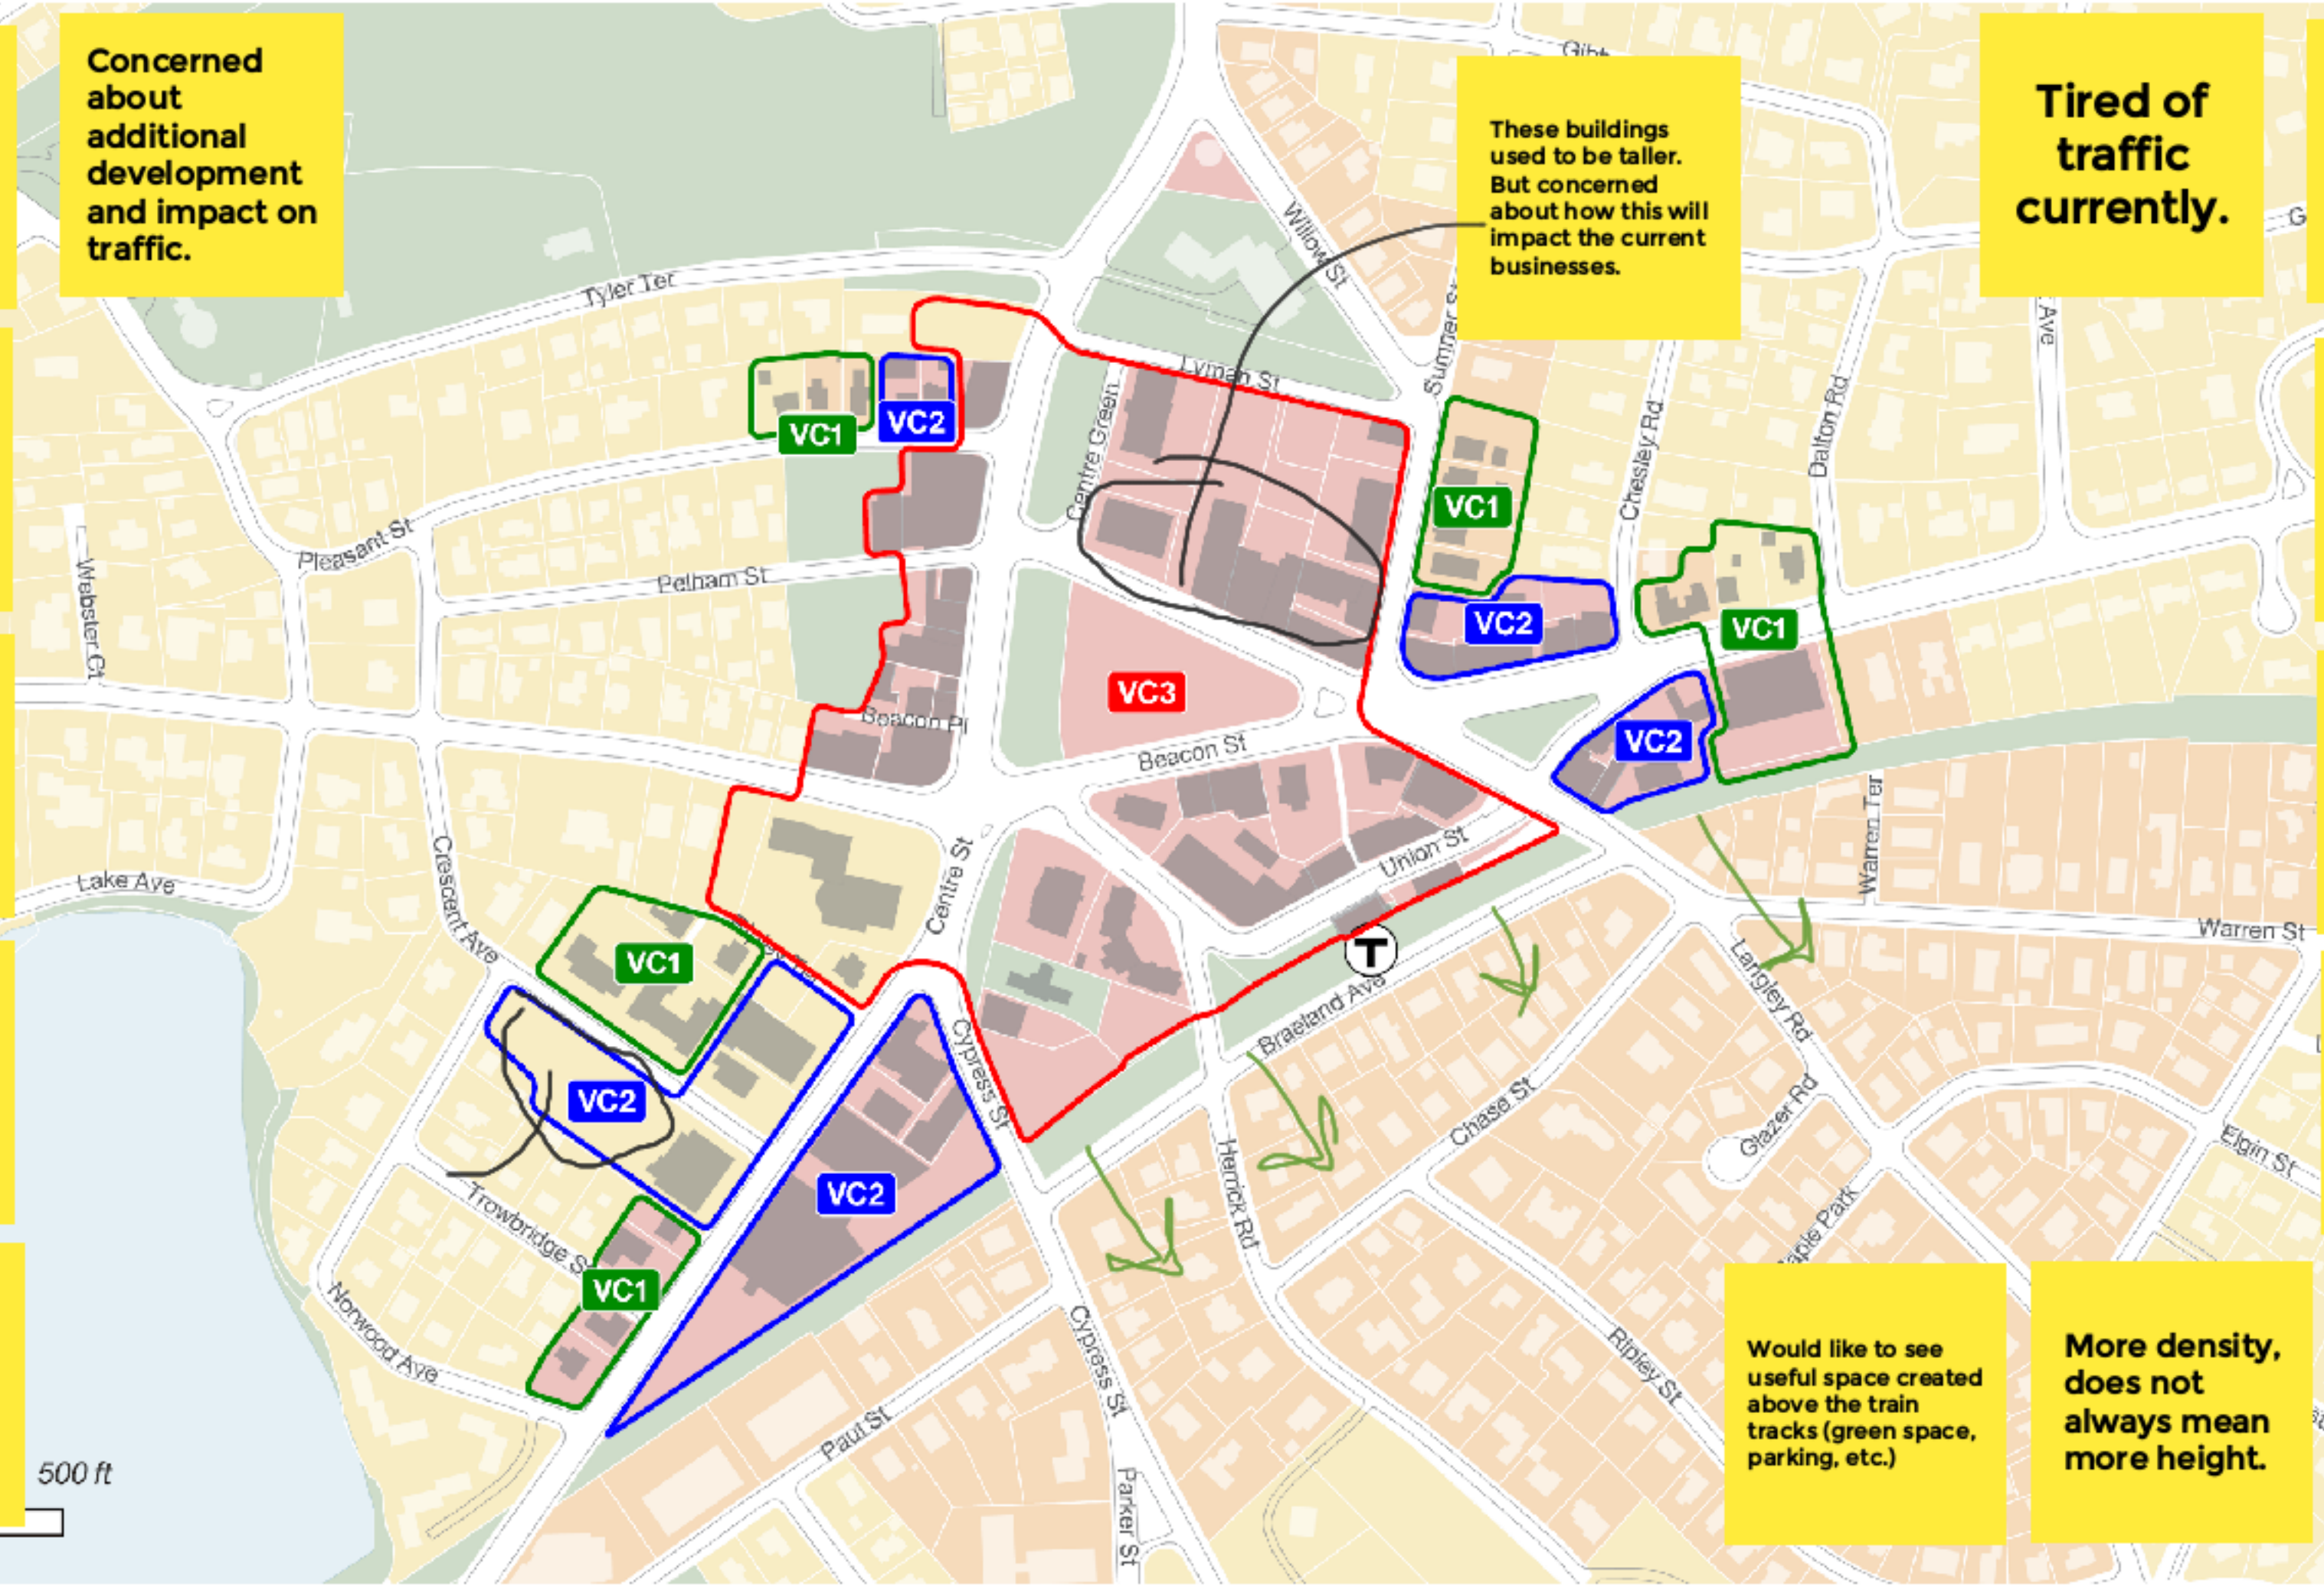
Increasing density is appropriate within/around the village centers. But incentives should be built into the zoning for preservation and reuse.

Concerned about additional development and impact on traffic.

Tired of traffic currently.

Concerned the proposal not doing enough around accessibility and green space. Also concerned about traffic.

Will there be assistance to help properties in the VC zones?

These buildings used to be taller. But concerned about how this will impact the current businesses.

Believes the height reduction for VC3 should also be required when abutting VC1.

Does not agree that VC3 zones should abut SR zones.

More VC1 is appropriate here.

Concerned if this lot is subdivided and gets developed.

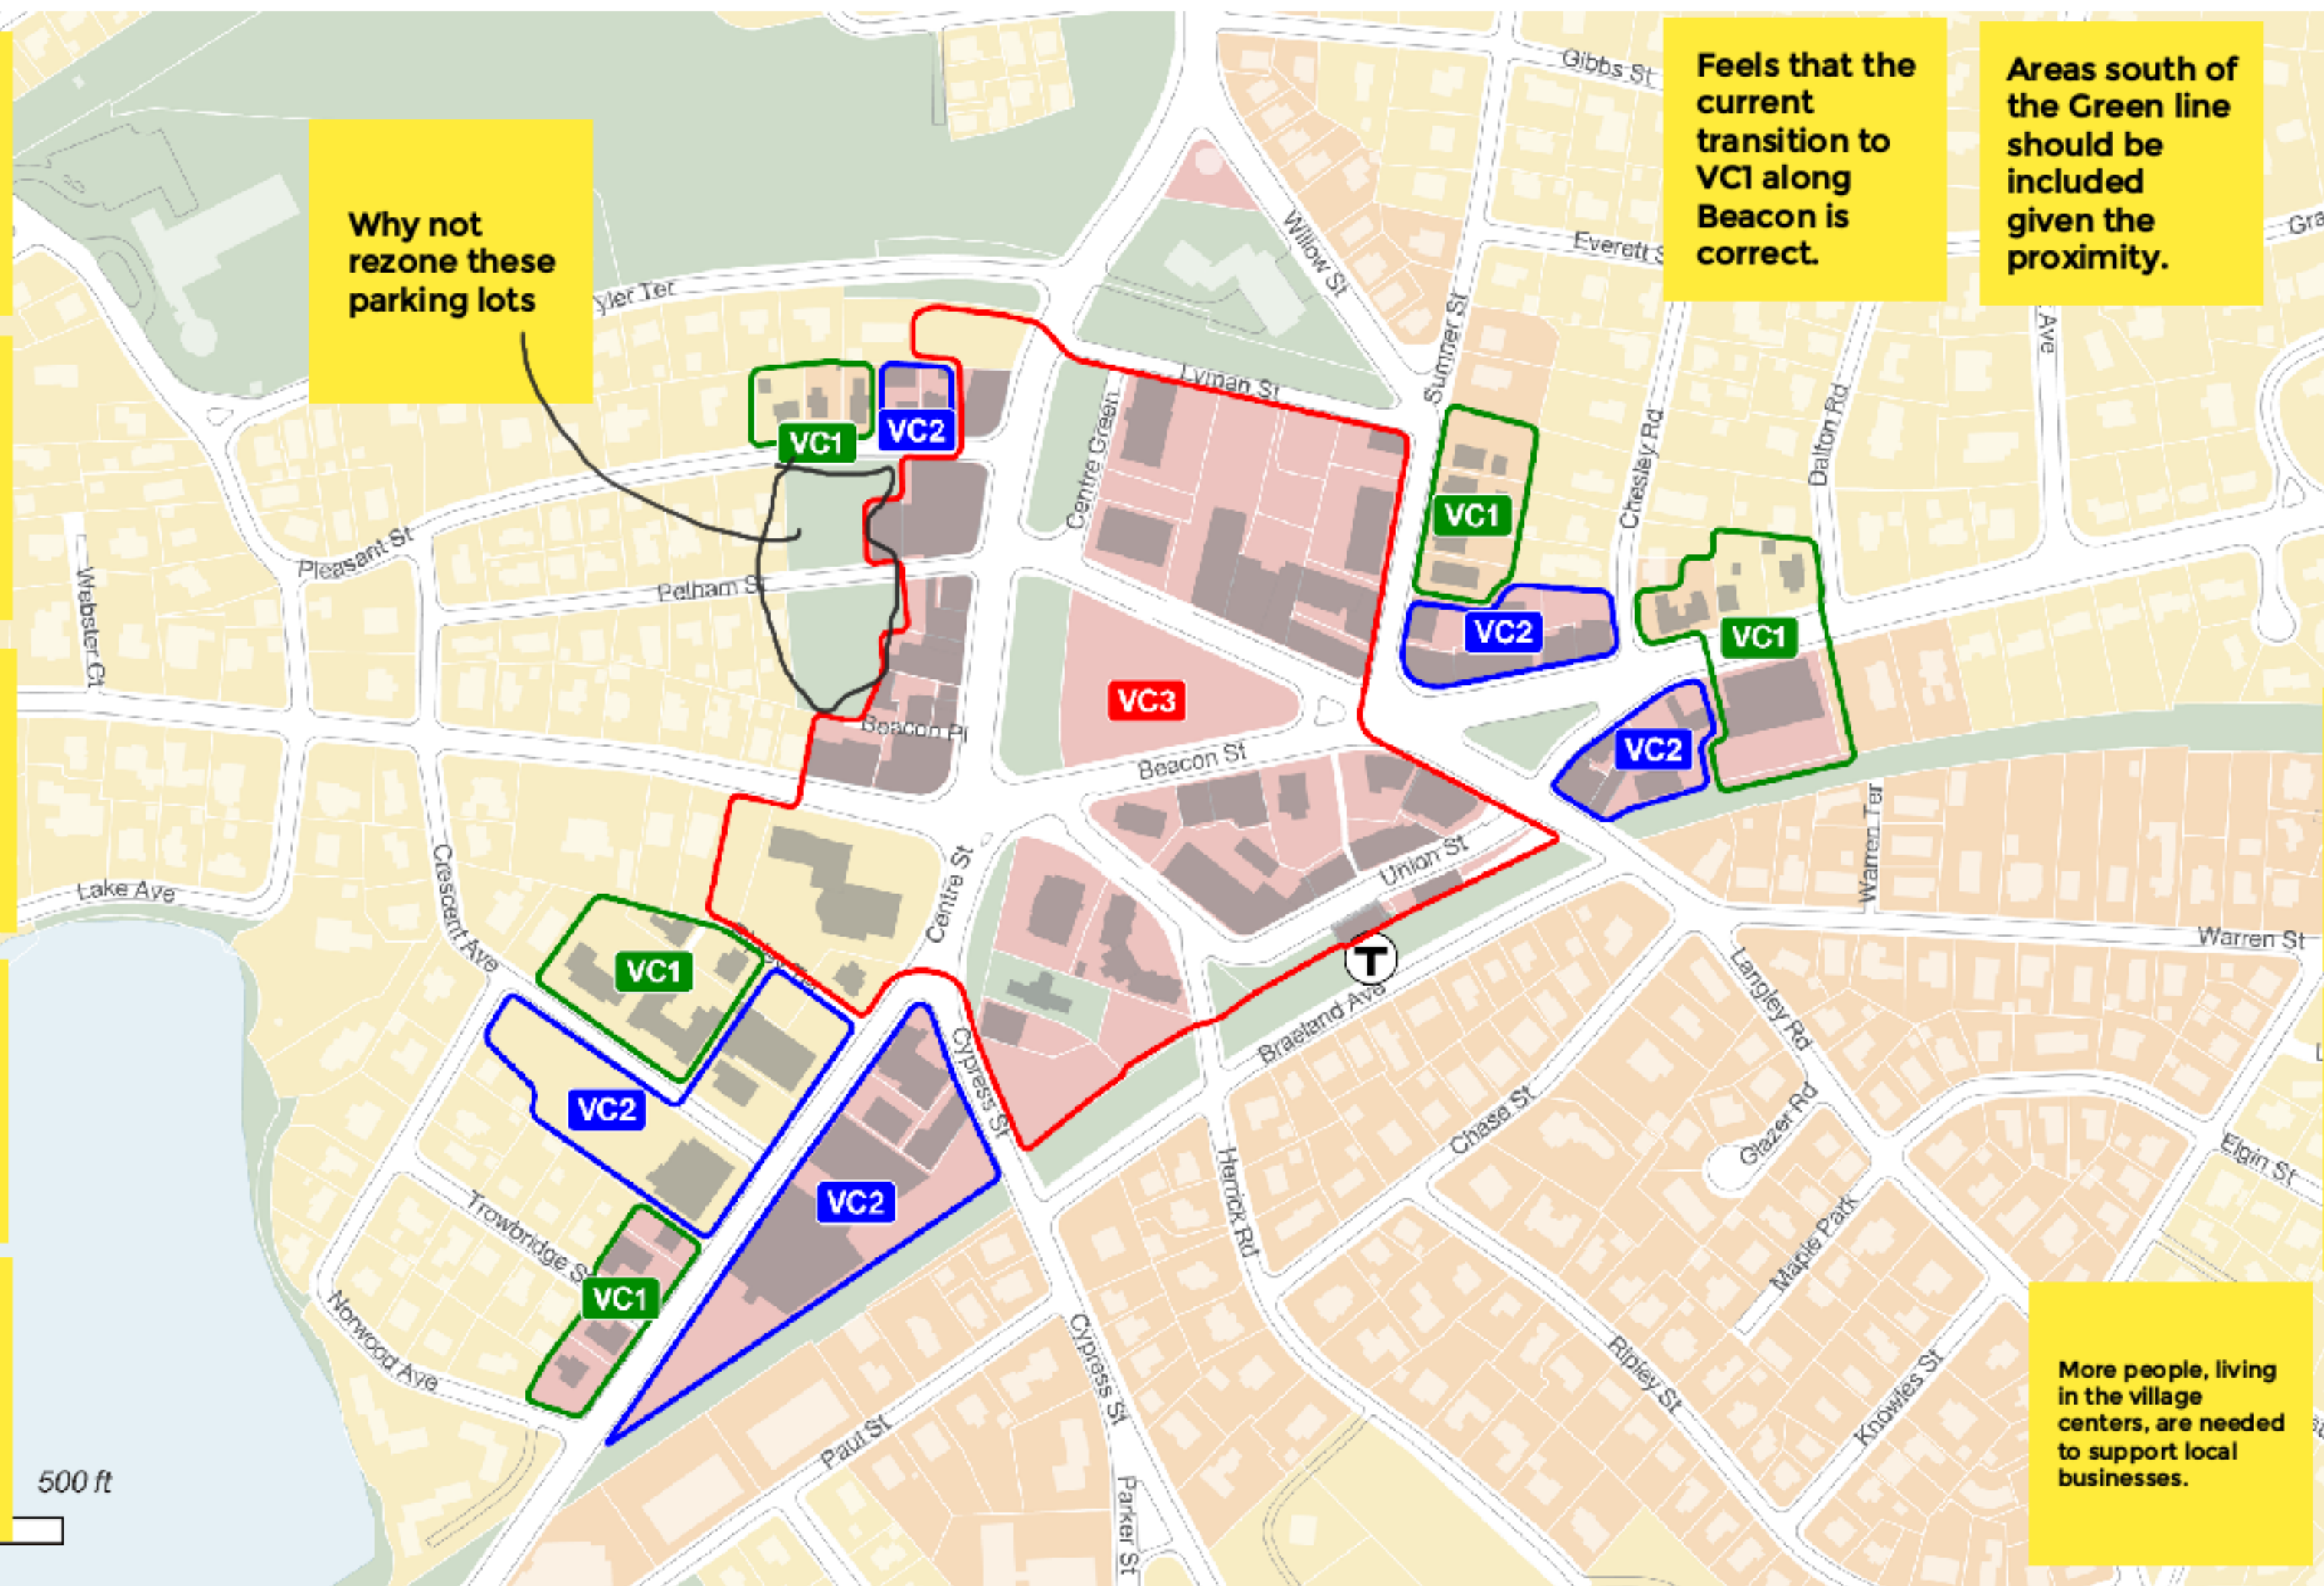
Small businesses could be appropriate in VC1 when along a more heavily used street.

We are in a housing crises, we need more housing. And village centers are great place to do provide it.

Would like to see useful space created above the train tracks (green space, parking, etc.)

More density, does not always mean more height.

Newton Centre is a vibrant village center currently.

Believes that other areas should be included in the VC thinking. Particularly areas on the south side of the T.

The Village Center Bank does not to be VC1, it could be VC2.

The transition to the residential does not need to equal the height, but could be a little higher.

Residential buildings that have converted into commercial should be zoned within the VCs.

Need to think carefully about rezoning historically significant buildings, like the churches (x2)

Why not rezone these parking lots

Feels that the current transition to VC1 along Beacon is correct.

Areas south of the Green line should be included given the proximity.

Concerned about existing businesses being displaced by new development.
